# 800GBASE-ER1 Architecture (comments 36 and 218)

Tom Huber (Nokia), Gary Nicholl (Cisco), Jeff Slavick (Broadcom),  
Eugene Opsasnick (Broadcom), Andras deKoos (Microchip), Mike  
Sluyski (Cisco), Dave Ofelt (Juniper)

# Alternative model for 800GBASE-ER1 based on FEC sublayer

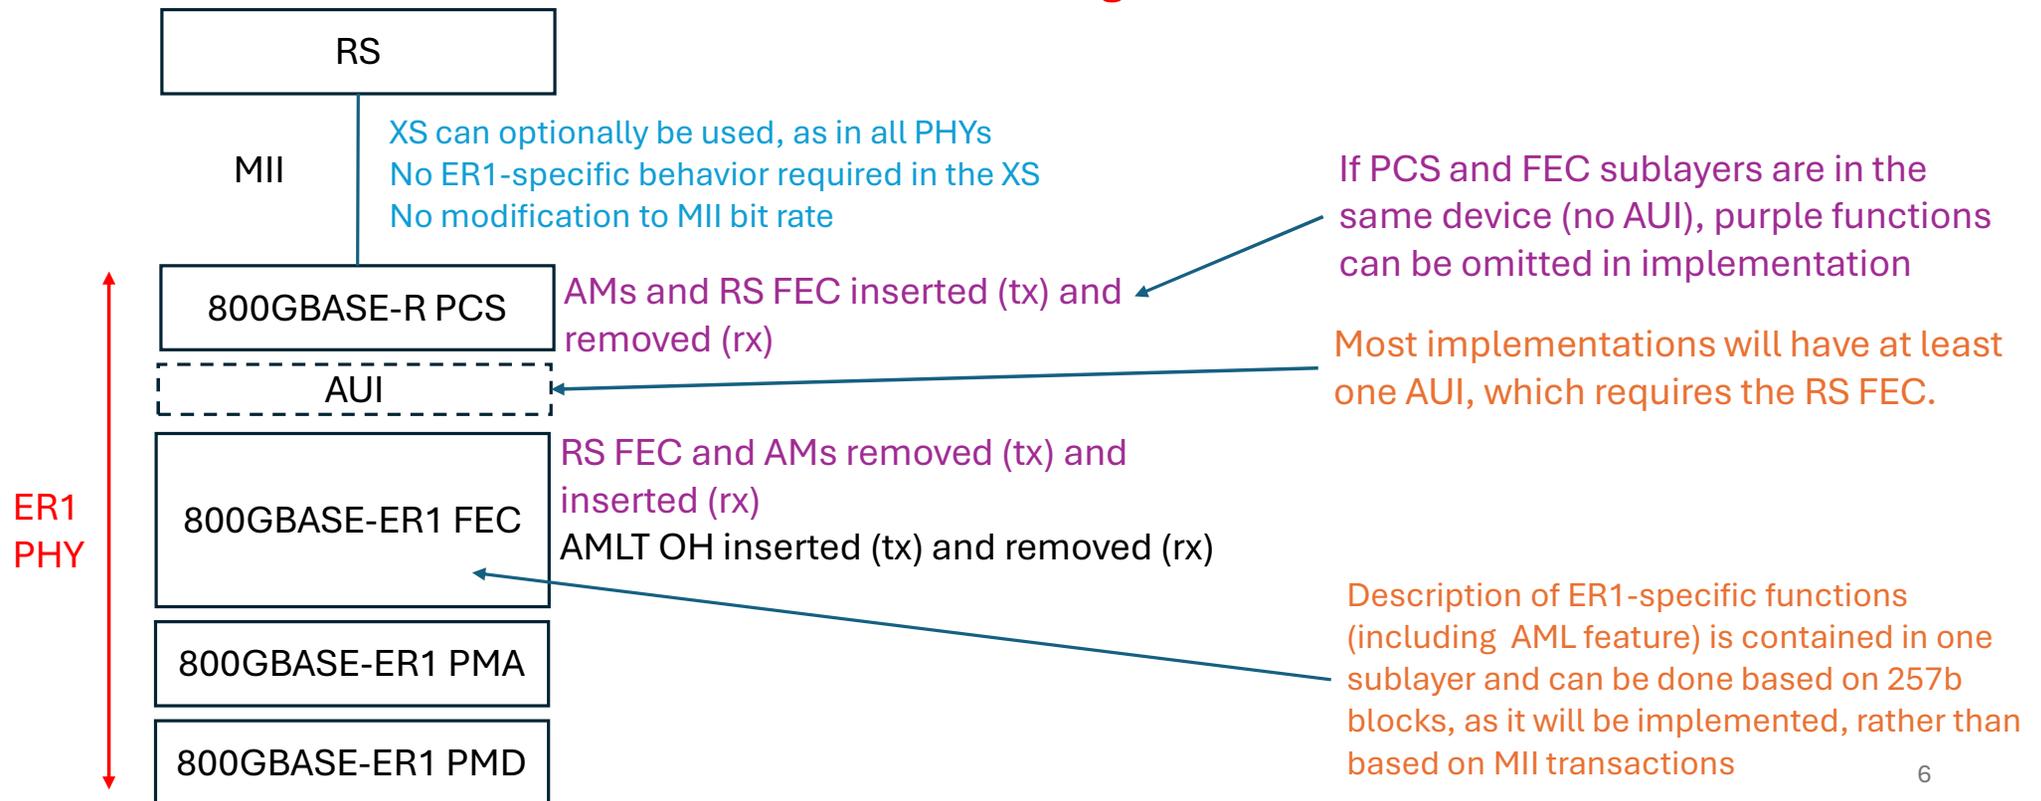
- The original rationale for treating ER1 as a separate PCS was based on ER1 using a different FEC from 800GBASE-R on the ER1 link
  - Implementations using pluggable modules would utilize a segmented FEC architecture since the AUI will use RS(544,514) FEC
  - Use of the XS and a separate PCS was seen as a natural way to support this segmented FEC architecture
- An alternative is to use the 800GBASE-R PCS and define an 800GBASE-ER1 FEC sublayer that:
  - Terminates the RS FEC
  - Maps 257b blocks into the ER1 frame and adds the ER1 FEC
- The alternative doesn't require changing the technical baselines; it is purely a change in how we document the PHY to better align with how people will implement it

This architecture aligns with 800GBASE-FR4, -LR4, and -LR1

# PHY\_XS functions used in ER1 FEC

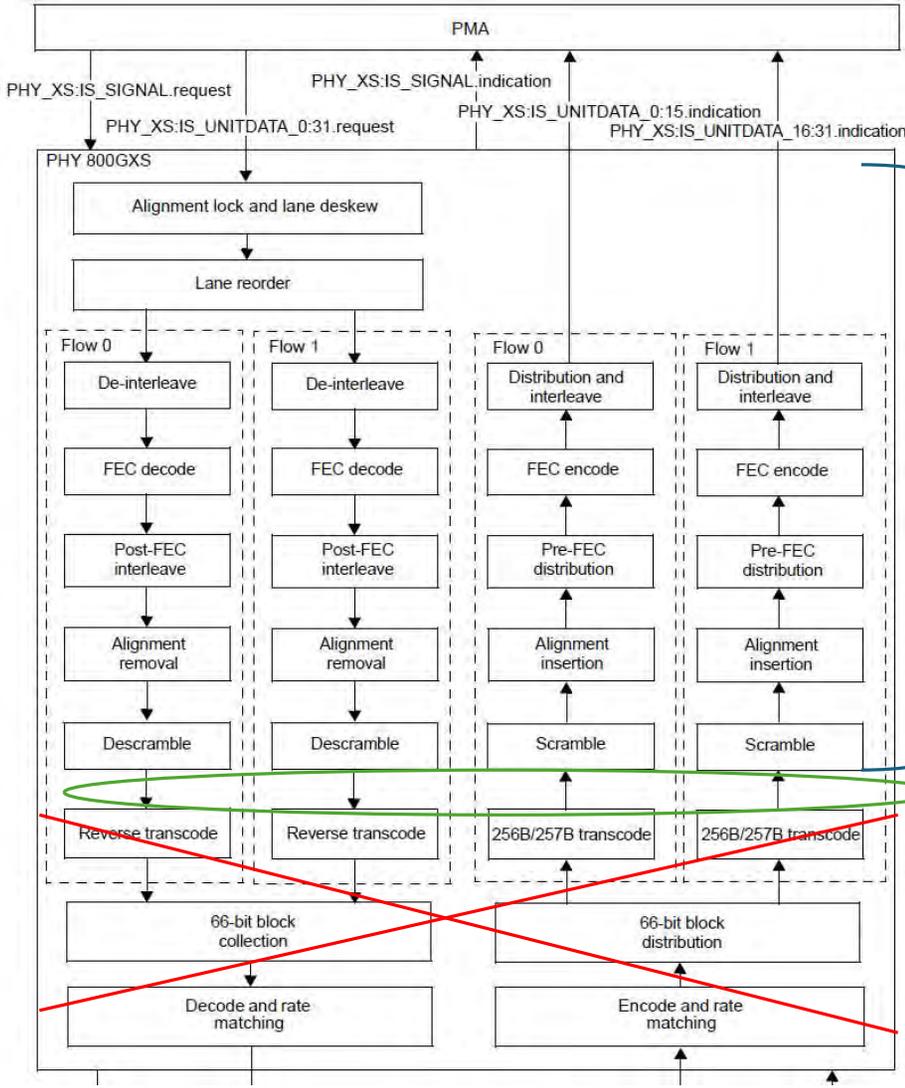
These functions are providing an “inverse RS FEC” function within the the ER1 FEC sublayer.

They can all be specified by reference to the PHY\_XS.

Add “flow merge”/”flow distribute” functions here to merge the two flows to a single stream of 257b blocks in the Tx path and distribute the single path to two flows in the Rx path

# ER1 PCS functions used in ER1 FEC

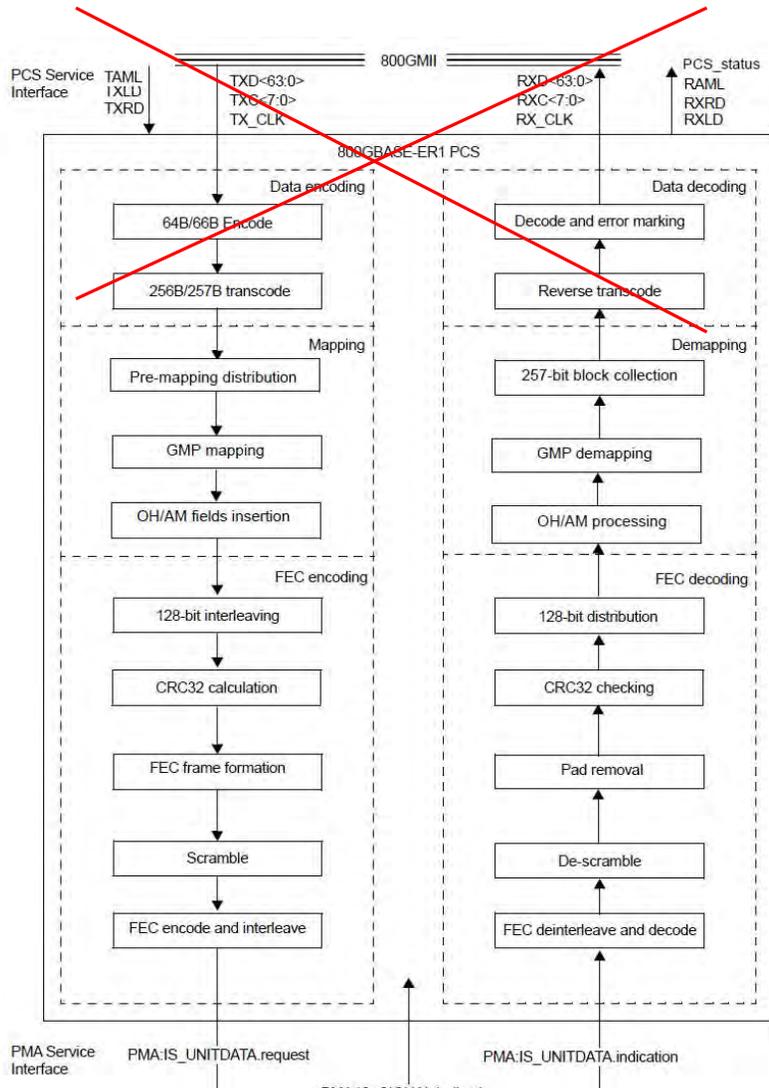
Replace this Data encoding/decoding block with a “Inverse RS FEC” block that uses functions from the PHY\_XS (see previous slide) plus a “flow merge” function to combine the two flows into a single 257b block stream

No changes needed as a result of changing the architecture to a FEC sublayer, other than in description of AML field in the OH/AM fields insertion function

# Clause 171 changes

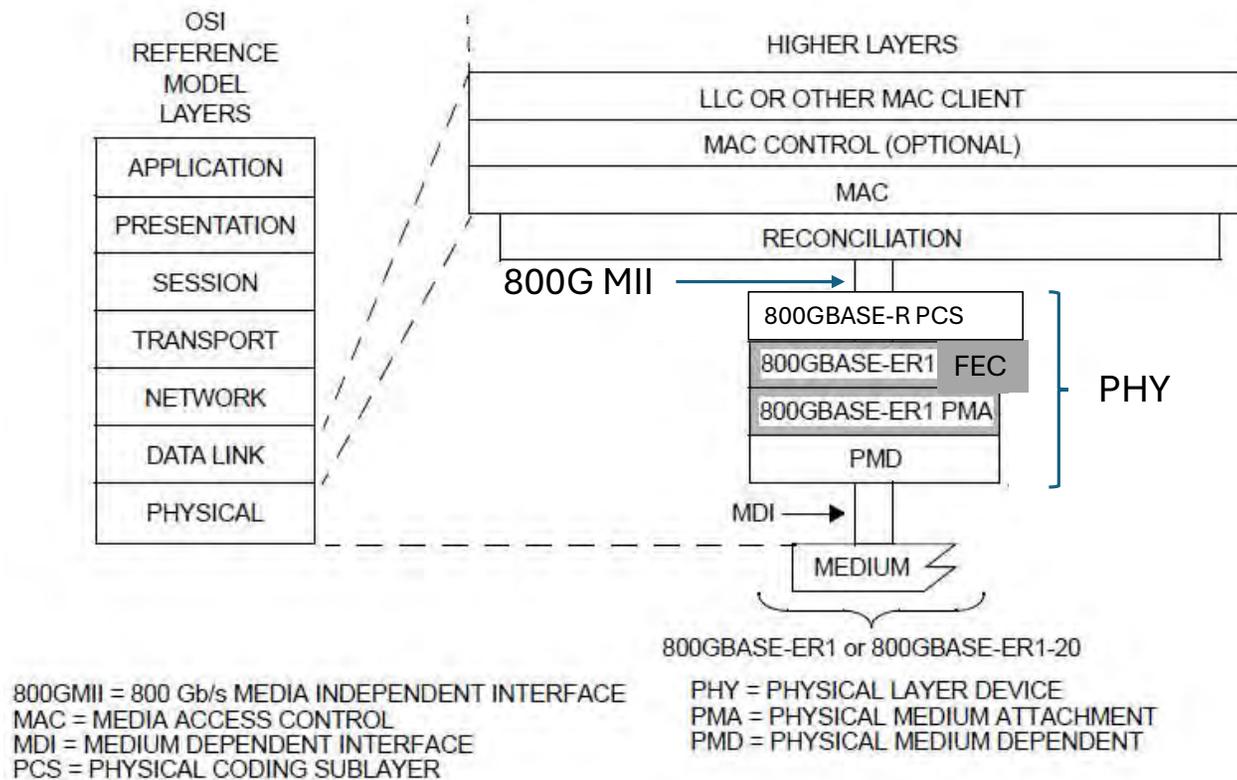
- Remove everything related to the ER1 PCS alignment marker location transparency feature in these subclauses:
  - 171.1.1: remove the bullet in the first list about optional support for enhanced PTP accuracy
  - 171.3:
    - Remove the bullet in the first list about PHY 800GXS
    - Remove the instruction to replace Figure 171-2 and the replacement figure
    - Remove 171.3.3 (there are no longer any changes being made)
  - Remove new subclause 171.6a, renumber new subclause 171.6b to 171.6a
  - Remove Table 171-2 (there are no longer any changes being made)
  - Remove “Enhanced PTP accuracy ability” row from Table 171-3
  - Remove new subclause 171.9.4.6a, renumber new subclause 171.9.4.6b to 191.9.4.6a

# Revised figure 186-2...

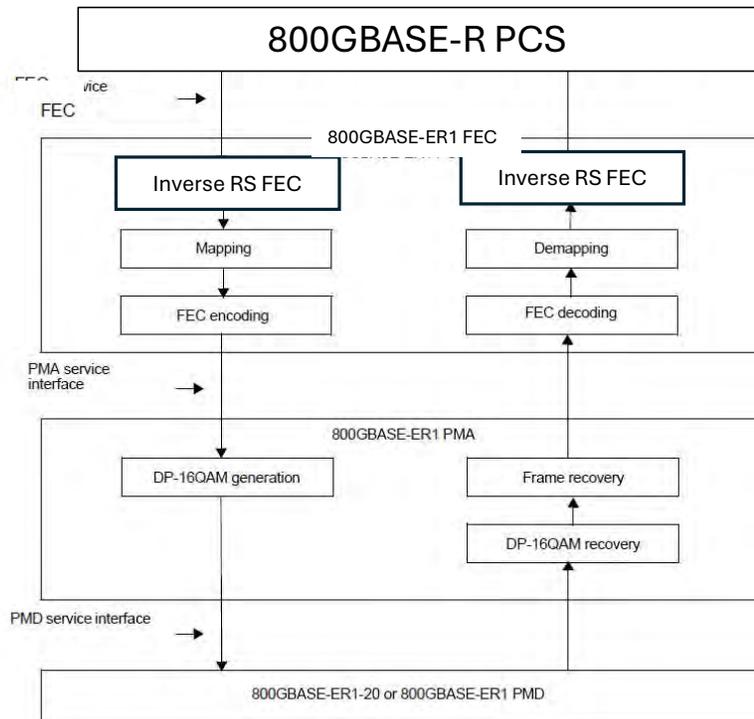
- Revise Figure 186-2 to reflect the new architecture
  - The 800GBASE-R PCS should be at the top, with an optional AUI.
  - Change PCS to FEC, and change the first block from “Data encoding” to “Inverse RS FEC”
